ENGINEER'S SEAL	LOS ANGELES CENTER	DRAWN BY WCWJ
	MASTER UTILITY PLAN	DATE 3-28-12
		21204-LAYOUT-3-28-12
	1606 CENTRAL AVENUE SUITE 201 ALBUQUERQUE, NM 87106 (505) 872-0999	SHEET #
DAVID SOULE P.E. #14522		JOB # 21204

ENGINEER'S SEAL 	LOS ANGELES CENTER GRADING AND DRAINAGE PLAN	DRAWN BY WCWJ DATE 5-15-12 21204-LAYOUT-3-28-12
DAVID SOULE P.E. #14522	 1606 CENTRAL AVENUE SE SUITE 201 ALBUQUERQUE, NM 87106 (505) 872-0889	JAN 14 2013 JOB # 21204

Lowe's Pad Development
Los Angeles Center
Albuquerque, NM

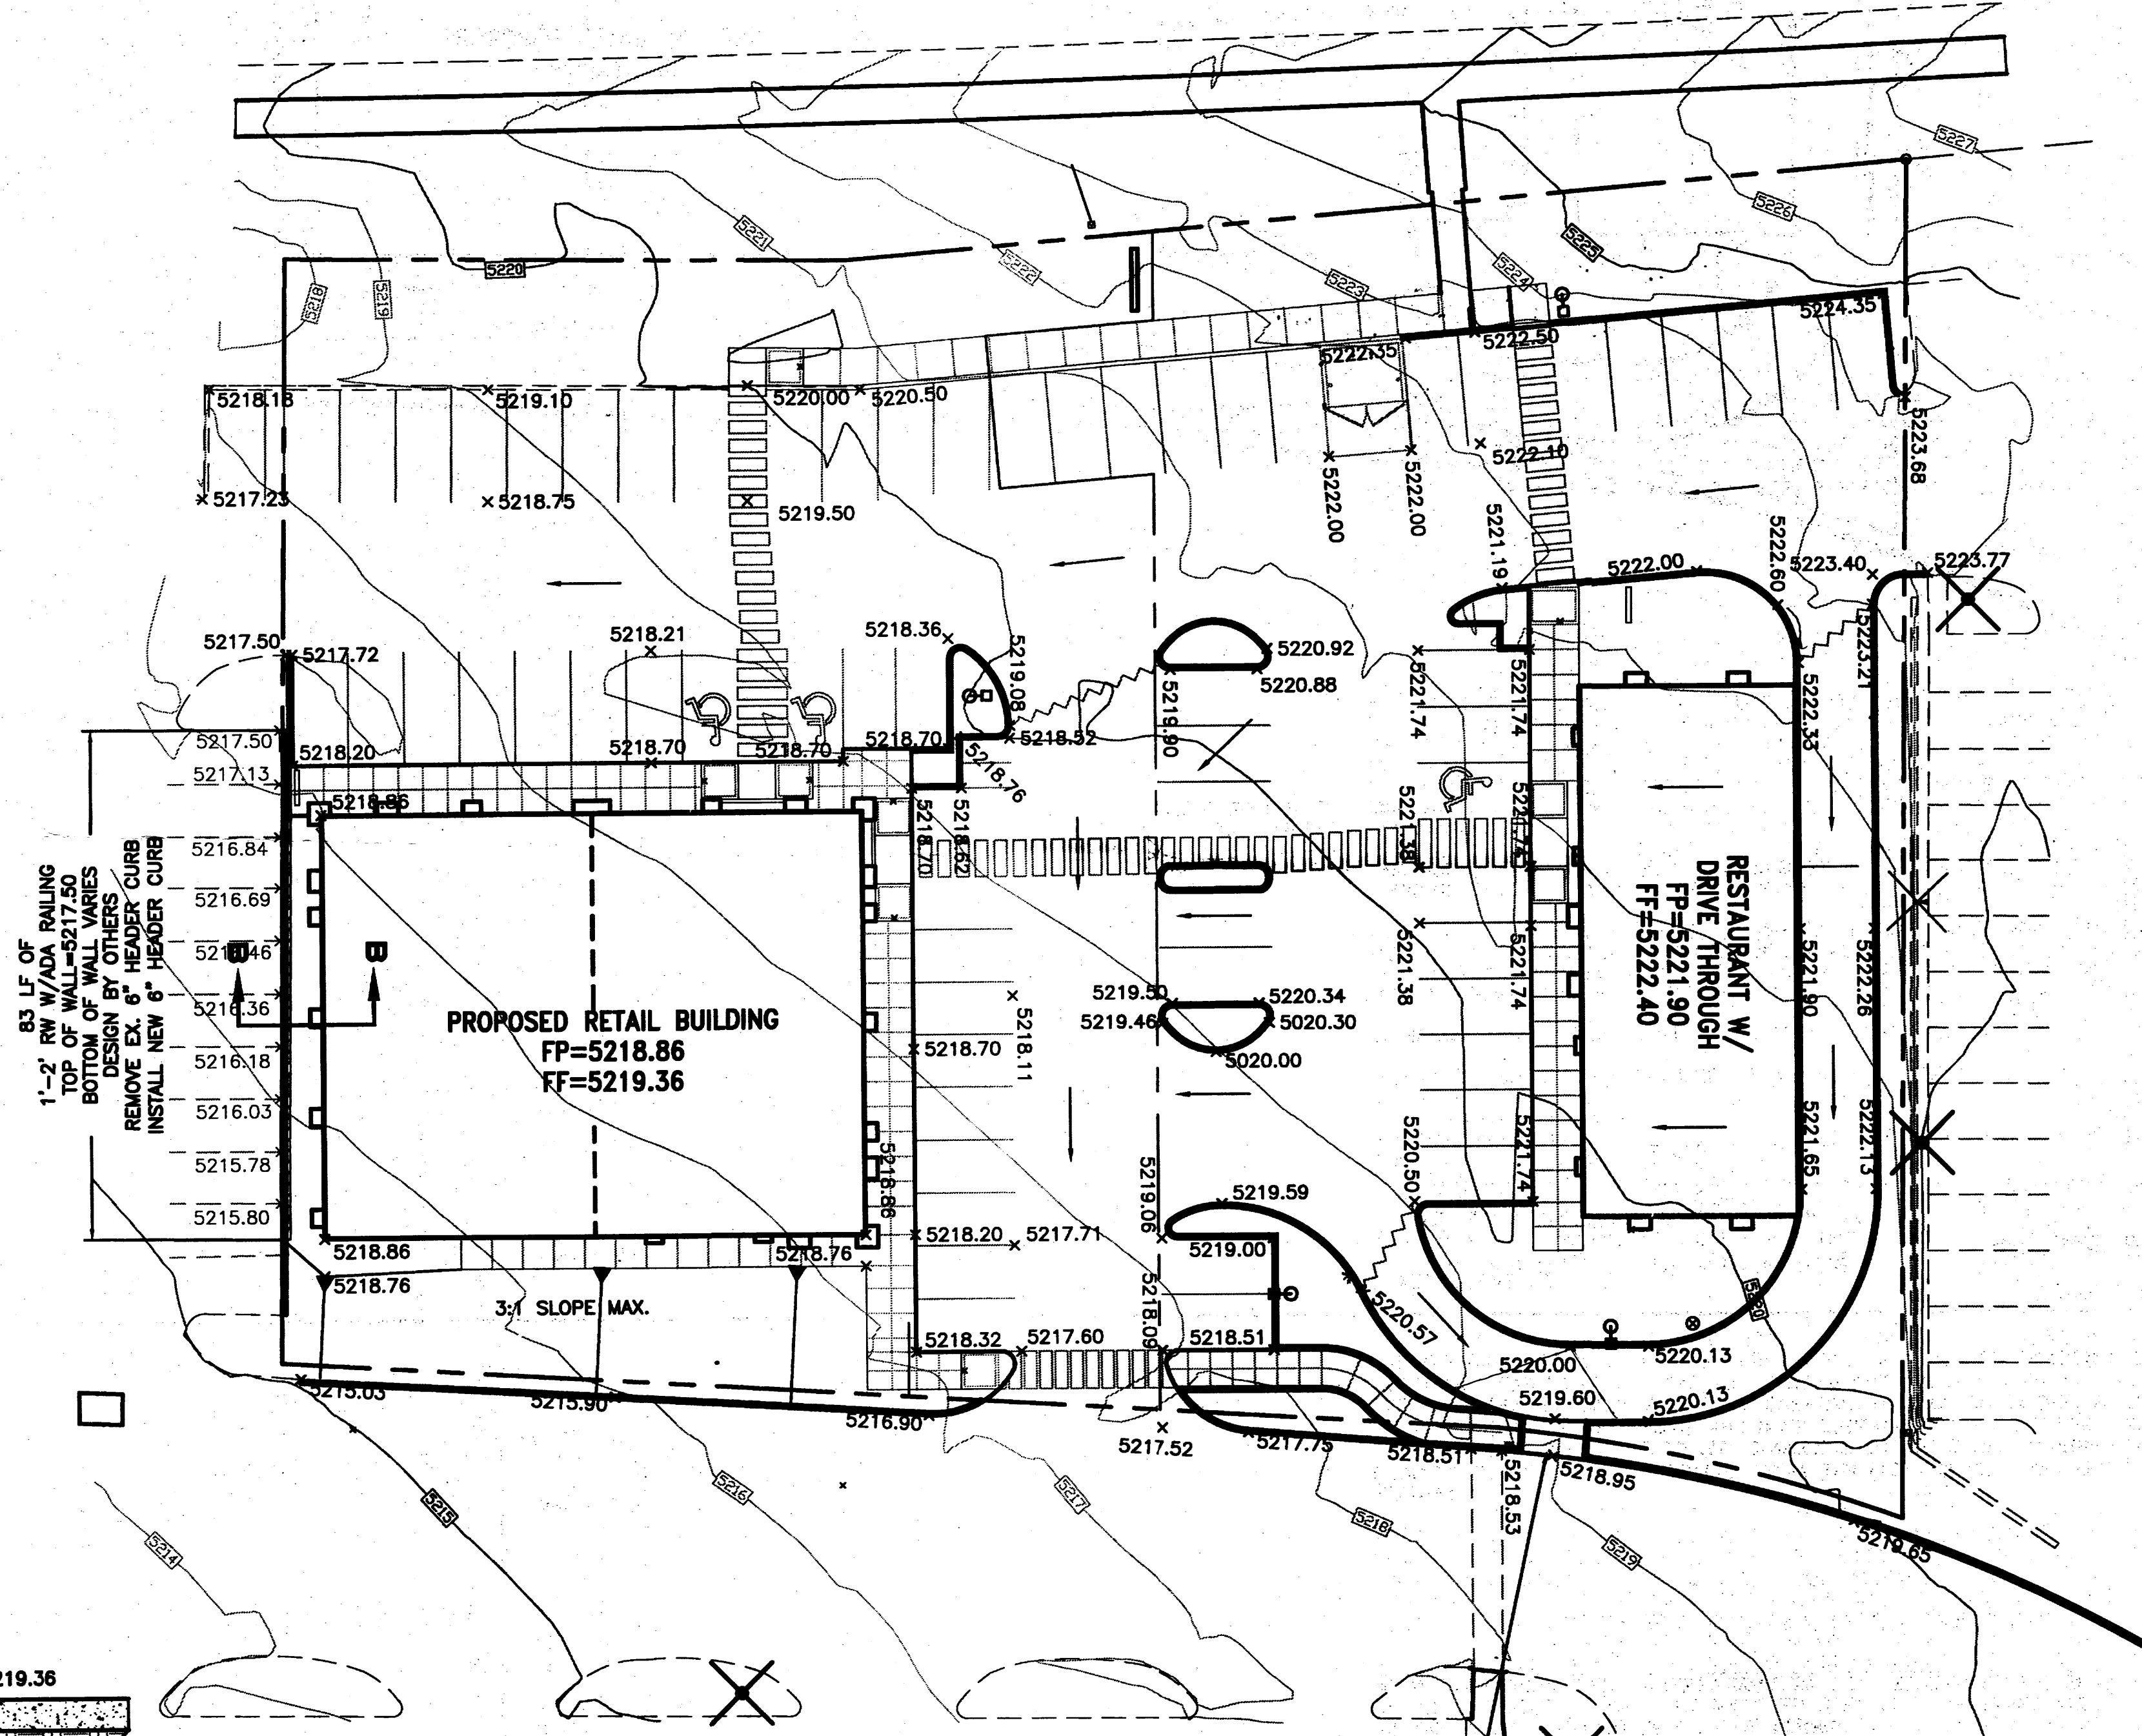
Where does
flow & runoff
go from
SUD Bldg?
Avoid erosion
on steep 5:1
or slopes

N-S Pedestrian
corridor on
Plan
w/ it be
maintained?
the site plan
What is impact
of drainage
thru the plan

Restaurant
Drains to
Must Drain to
San. Sewer

16' wide
Run-down
w/ 1/2" Trench
Along this
